## **ADDENDUM NO. 2**

## **NCSU** Renovations to the Don Ellis Building

SCO ID# 19-21547 NCSU ID# 201920037 SFK PROJECT NO. 1368-20

**December 13, 2023**

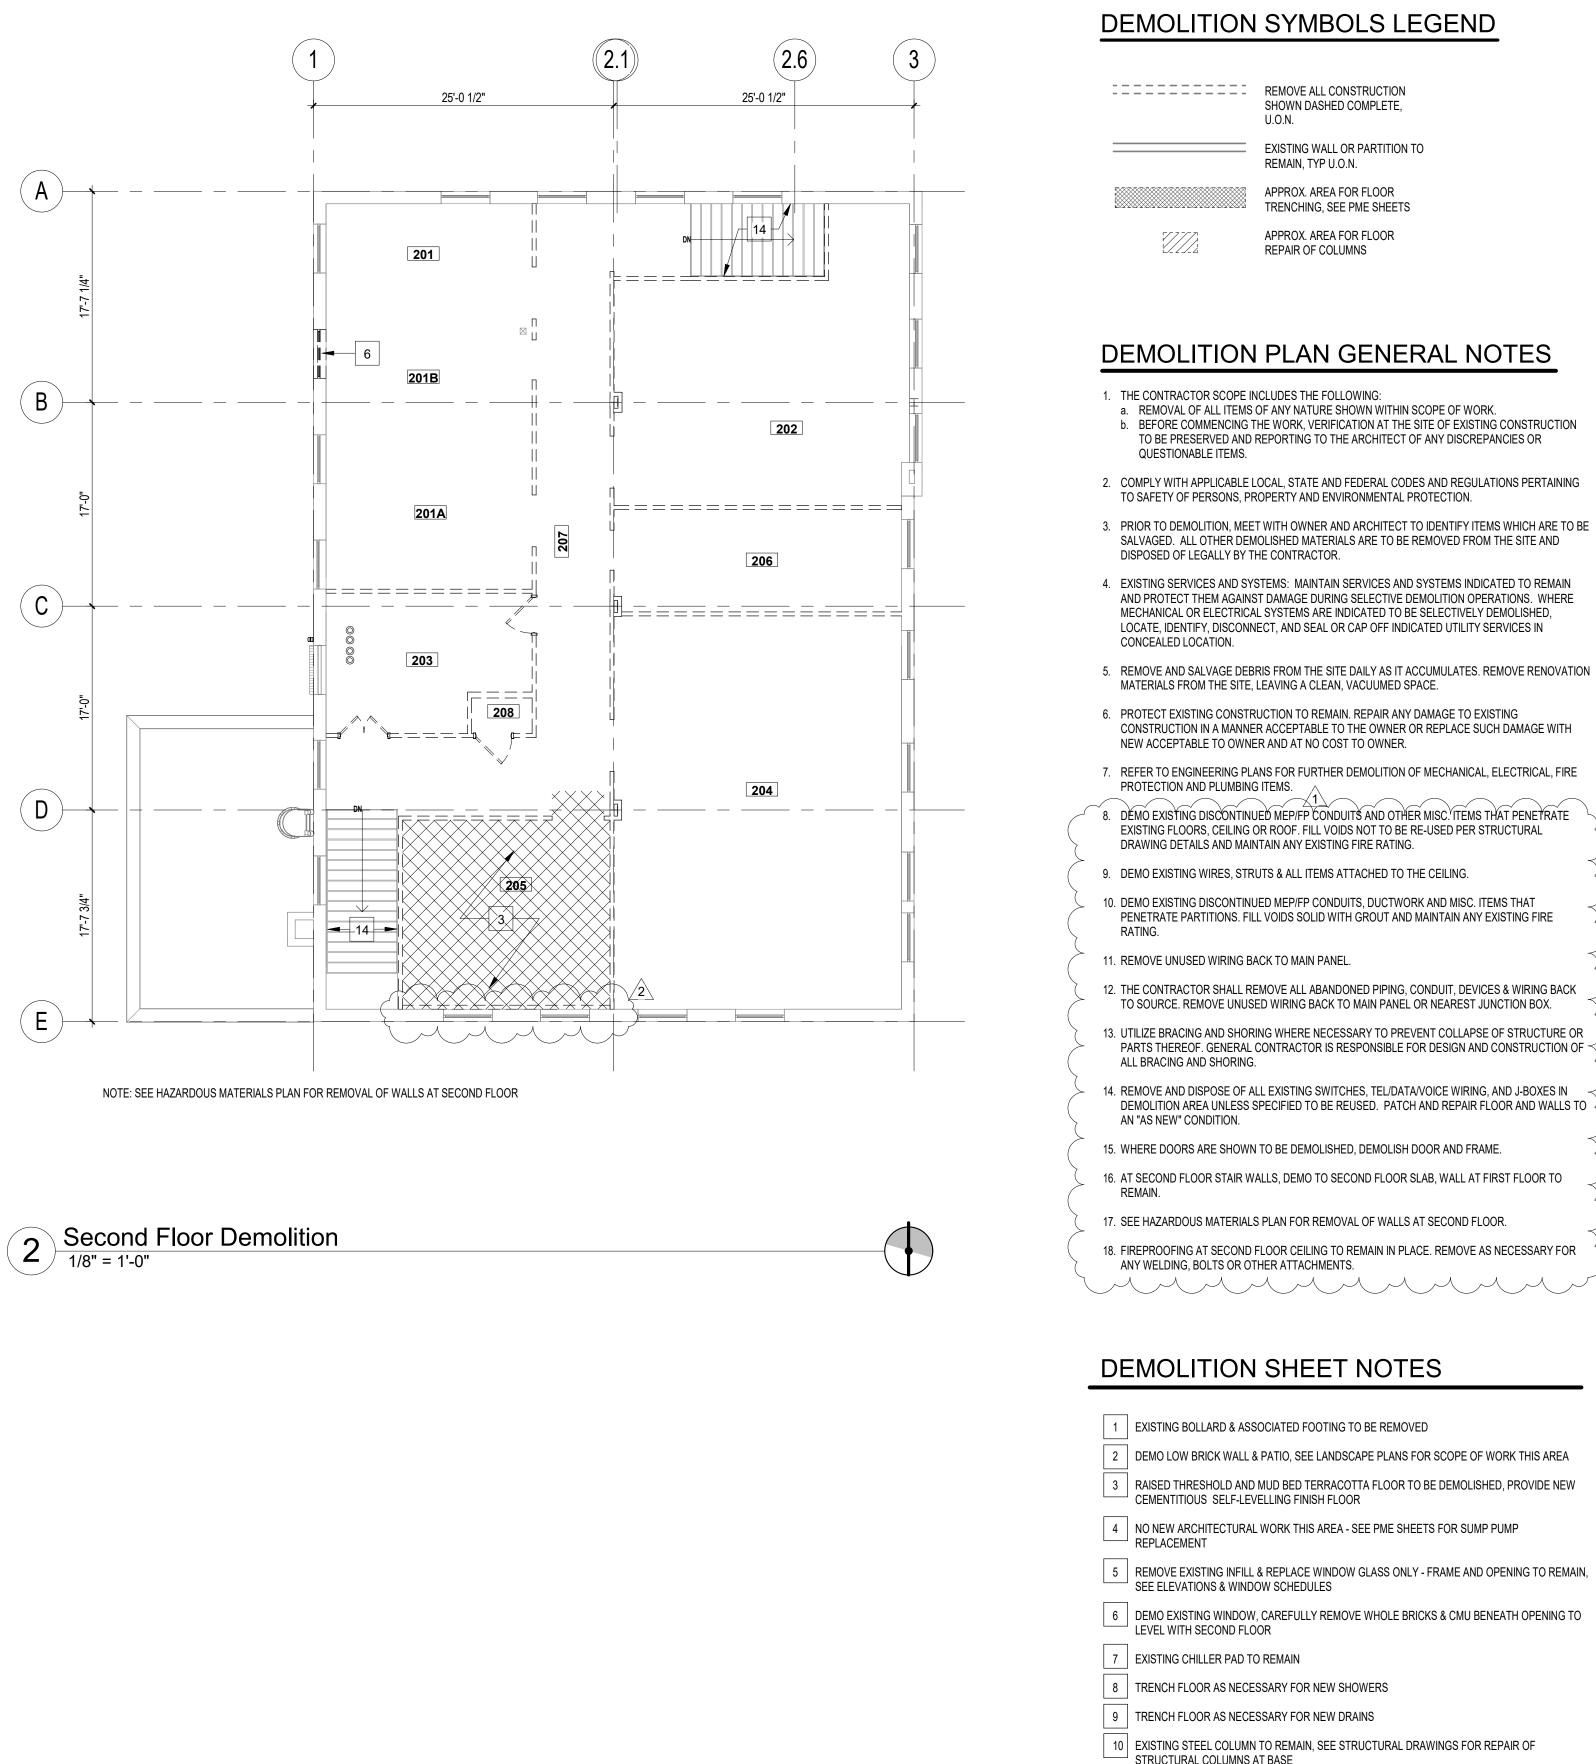
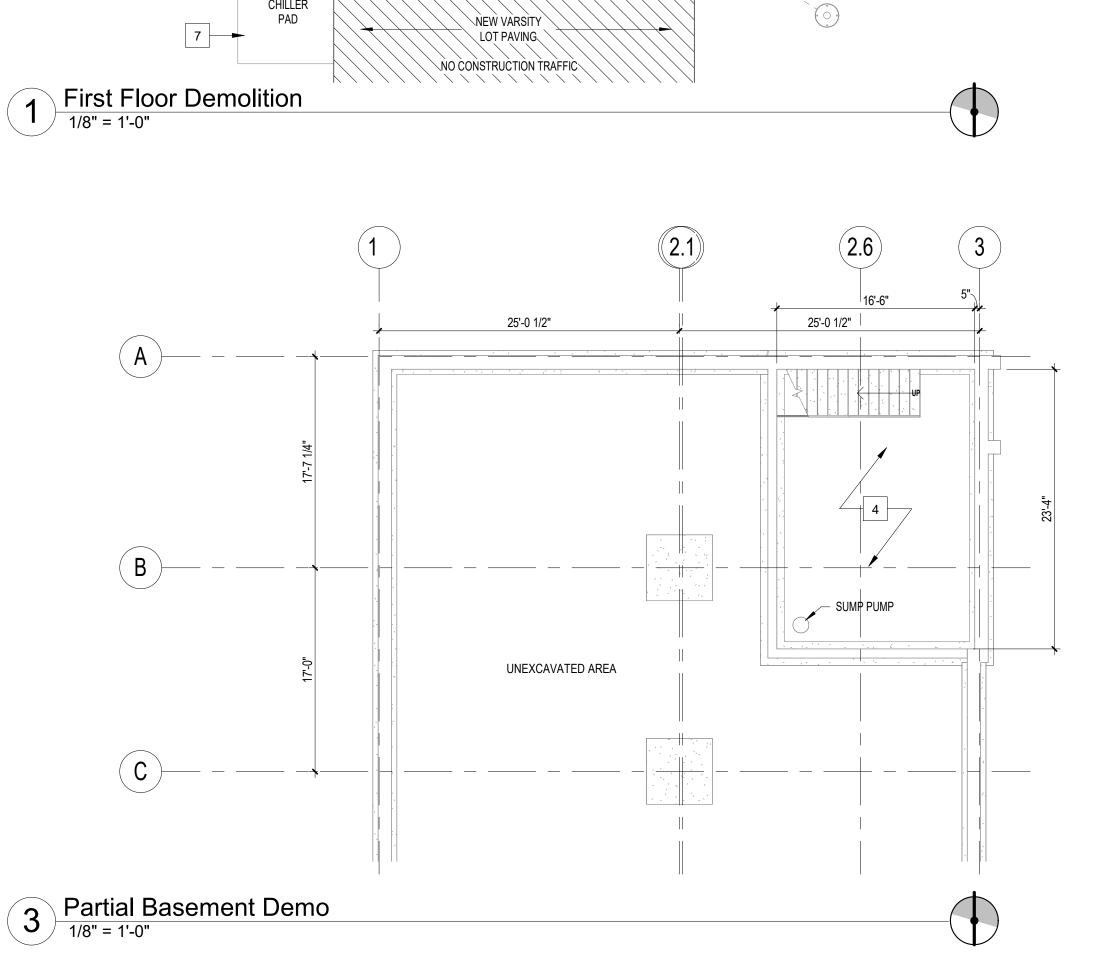
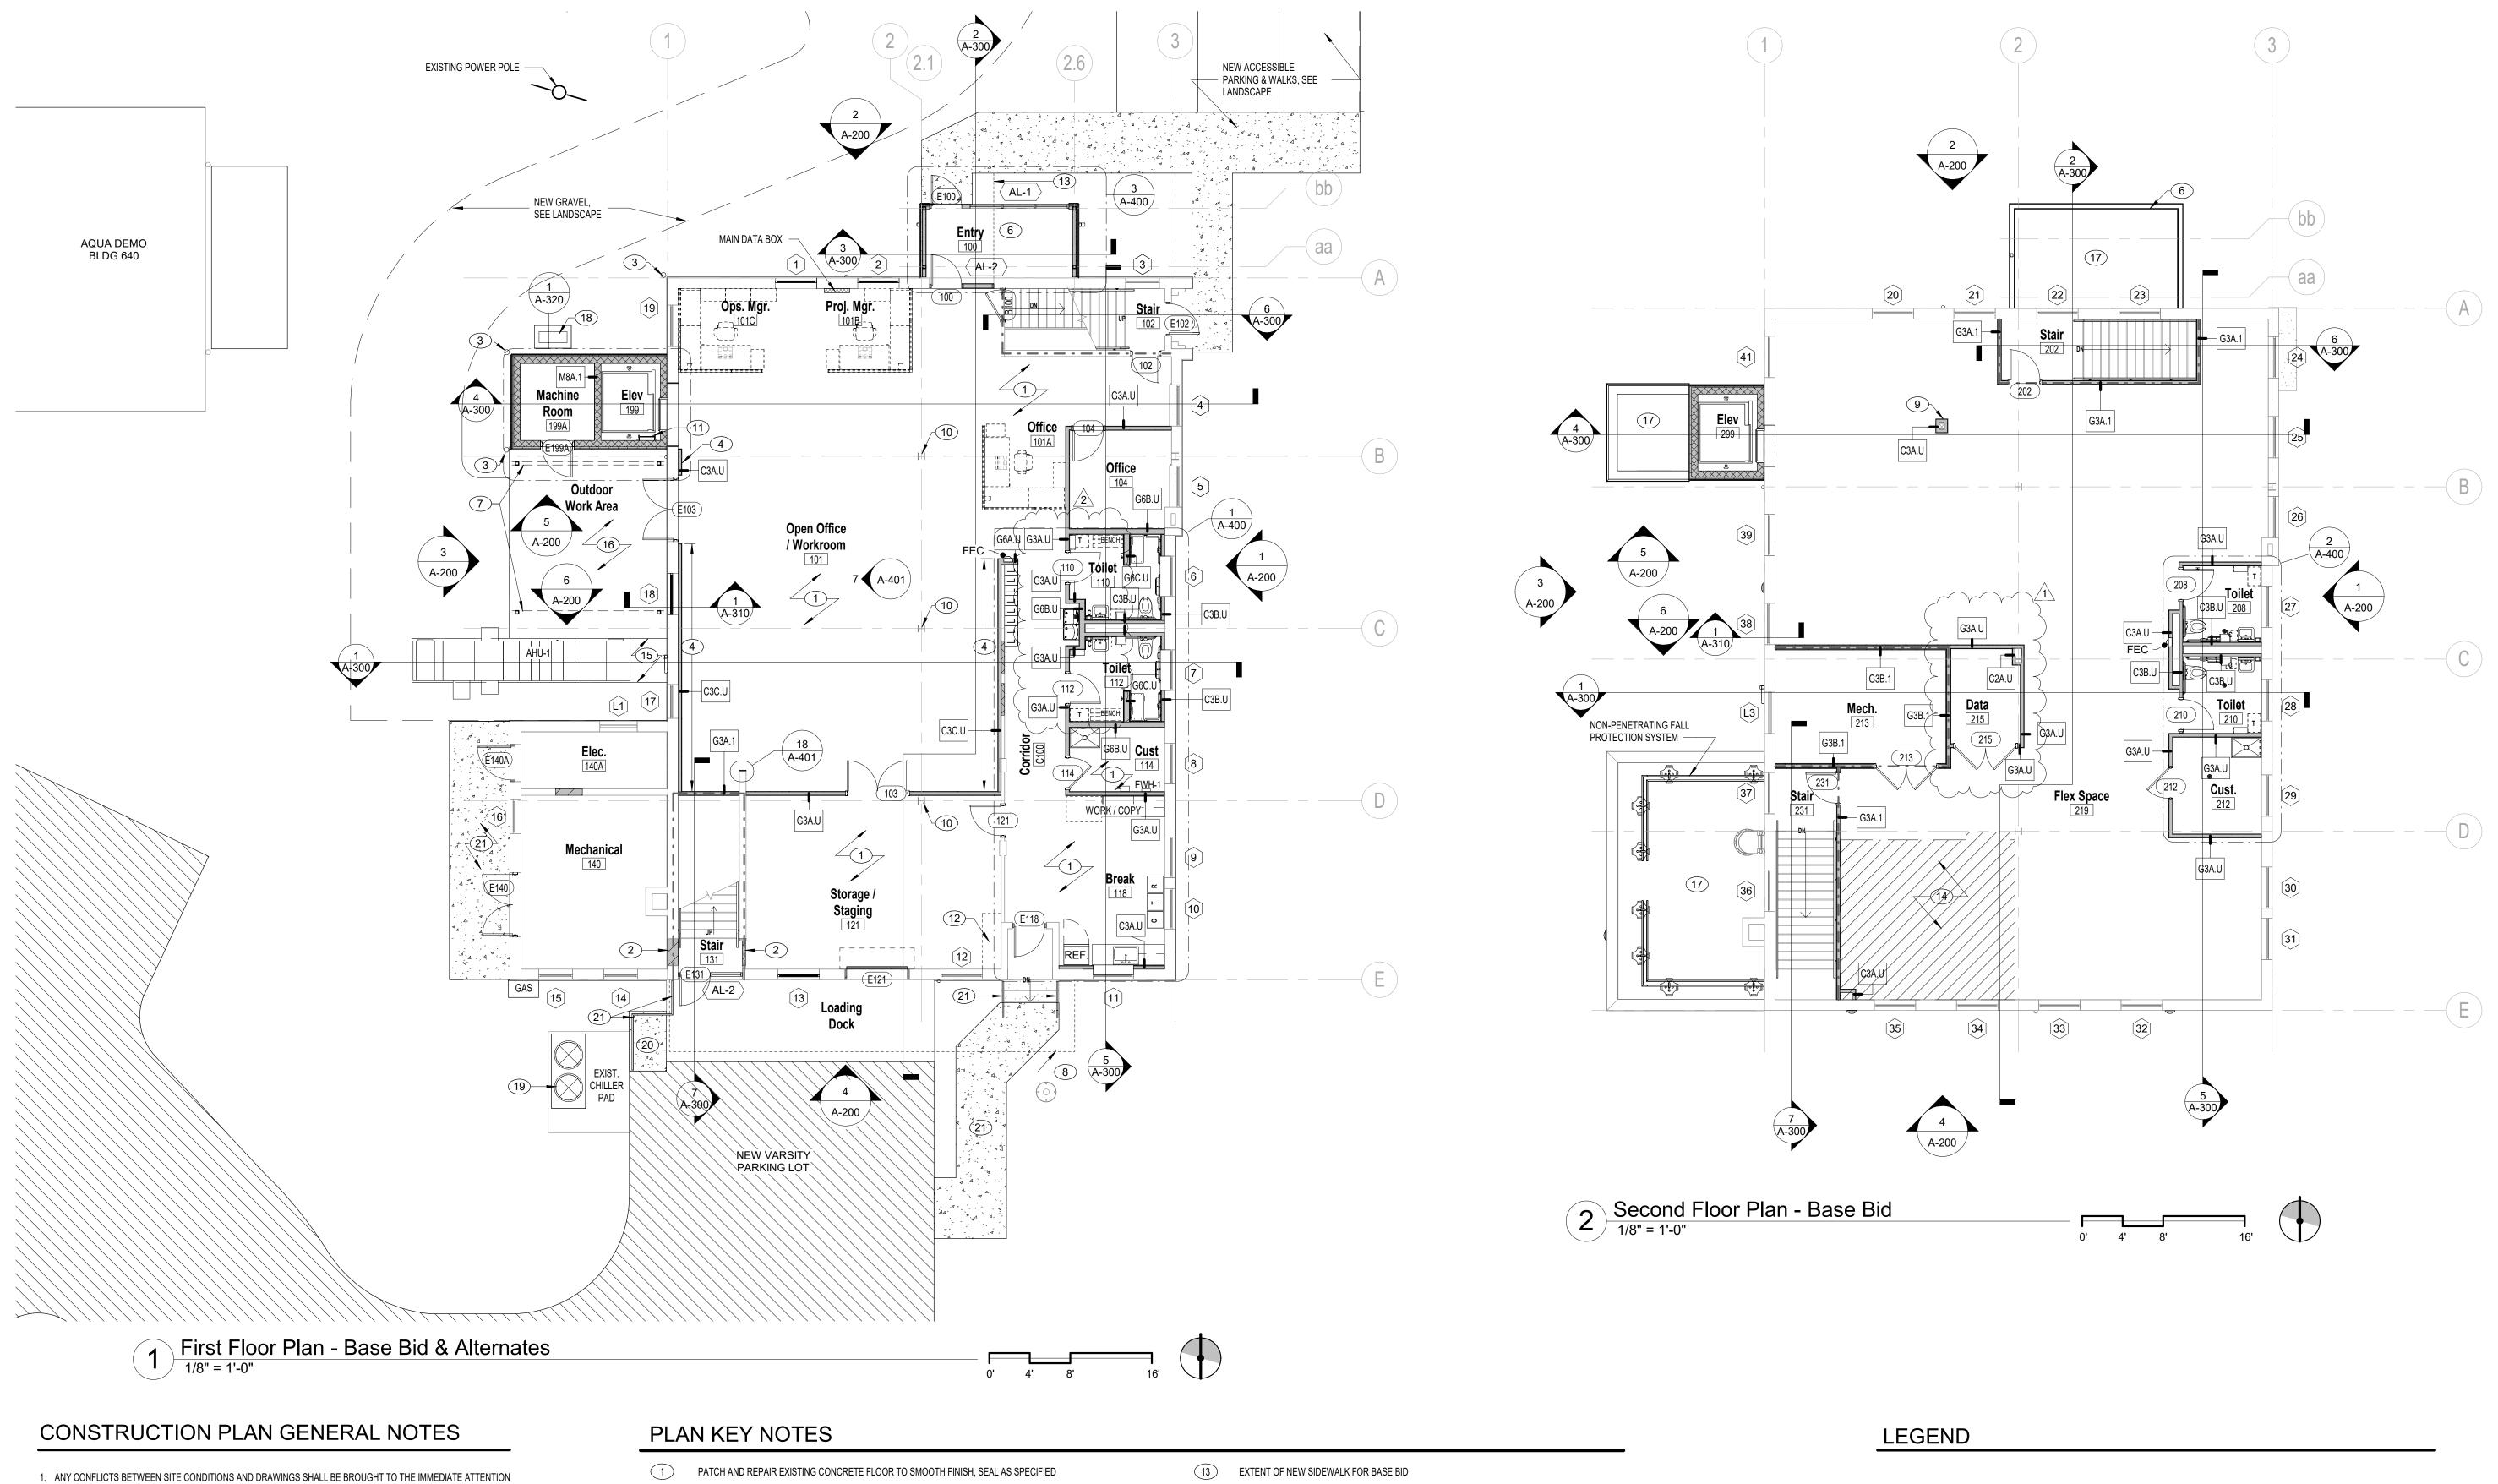
- 3. Sheet D-100: *Replace* with D-100 attached
  - a. See additional notes for demolition and location of additional glazed knee wall removal at room 205.

- b. See additional notes for demolition of boiler.
- 4. Sheet A-100: *Replace* with sheet A-100 attached.
  - a. Door numbers added for first floor restrooms 110 and 112

**Exterior Elevations**

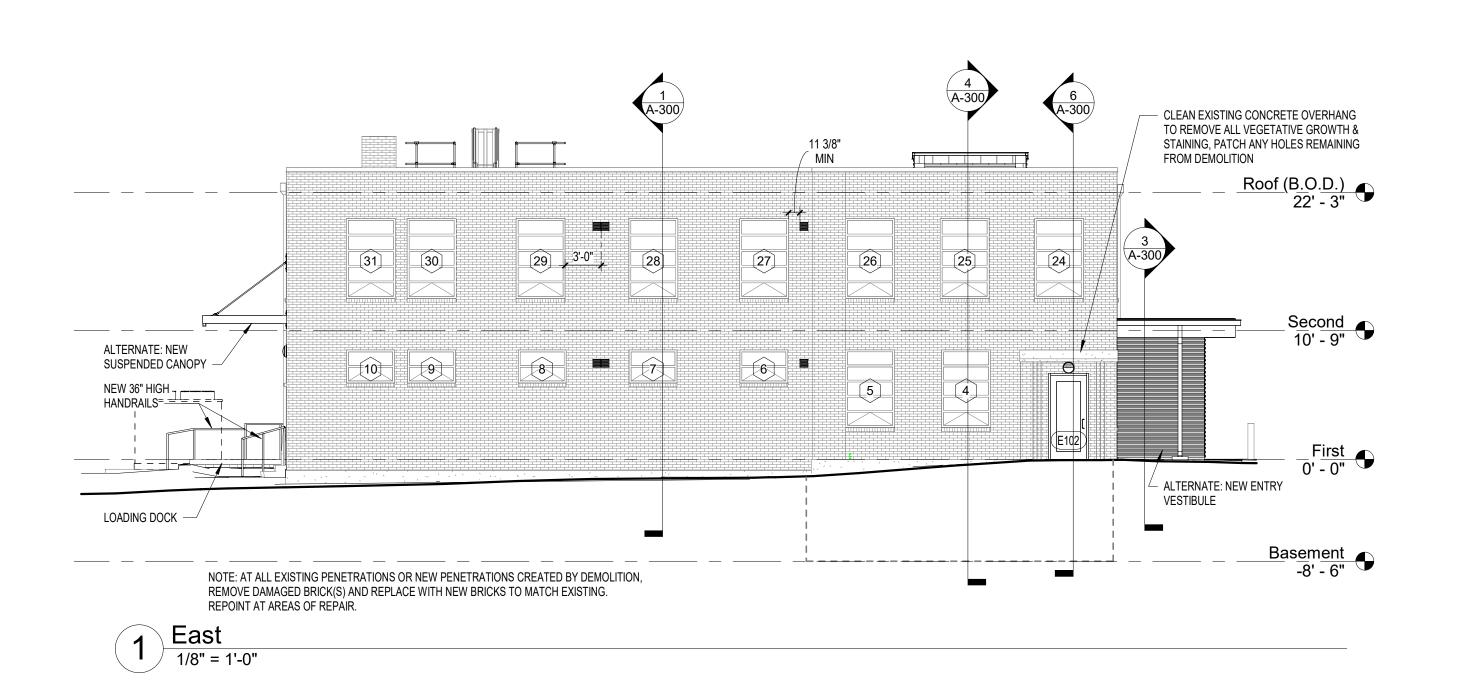
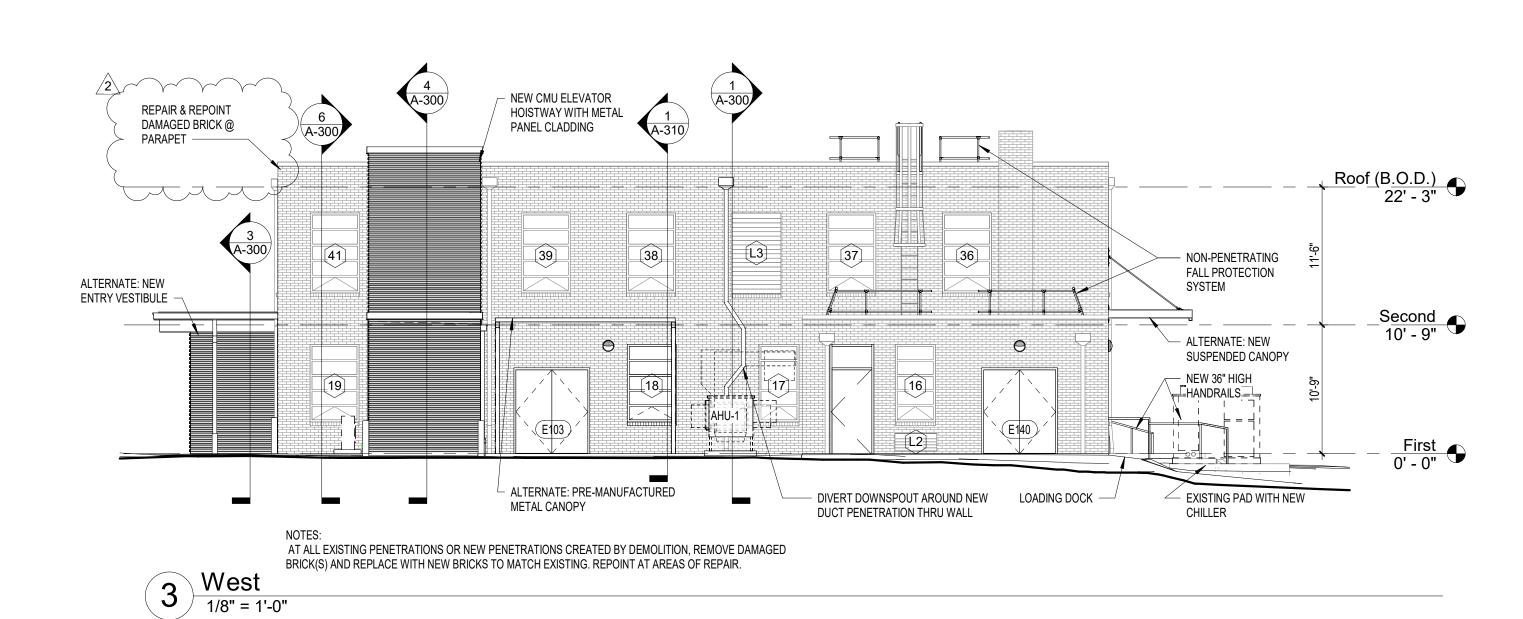
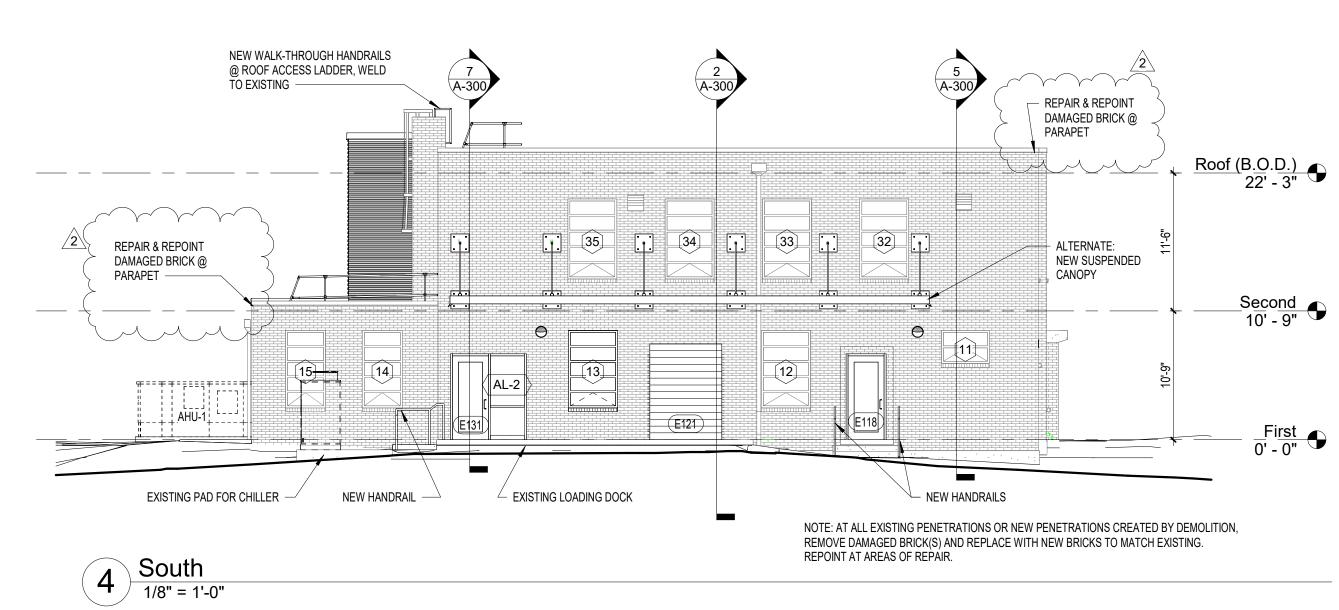
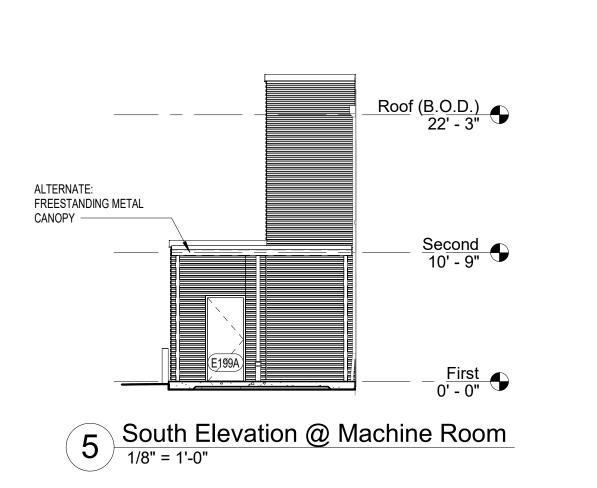
- 5. Sheet A-200: *Replace* with sheet A-101 attached.
  - a. Notes for brick repair added.
  - b. Locations for parapet damage repair added
  - c. North elevation of electrical room added with notes.

- d. Notes for sealant replacement and painting at existing steel lintels and coal chute.
- 6. Sheet A-300: Replace with sheet A-300 attached
  - a. Minimum clearance for duct work shown in section 1.
